PLANNING AND ZONING AND COUNTY COUNCIL INFORMATION SHEET Planning Commission Public Hearing Date: December 16th, 2021

Application: 2021-05 Turnberry (F.K.A. Unity Branch)

Proposed Use: 195 Single-Family Lots as a Cluster Subdivision

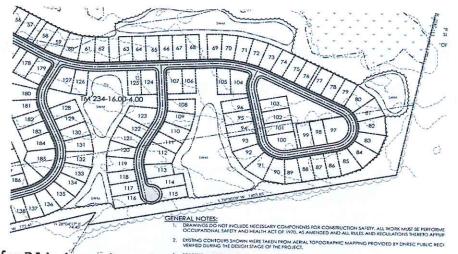
- 24 Independence homesites effected (red line area)
- Average \$25,000 lot premiums paid for "Wooded Lots"
- Total of approximately \$600,000 paid by 24 Independence homeowners at closing

- First cone is Lot 250 property line

- 2nd cone is the 20 ft of common area
- 3rd cone is the 30 ft area defined on Unity Branch as the new wooded line

- Area of concern for 24 Independence homesites losing the forested backyards that premiums were paid for.
- Request Unity Branch (UB) developer look into increasing the "Wooded Line" buffer zone by 50 feet.
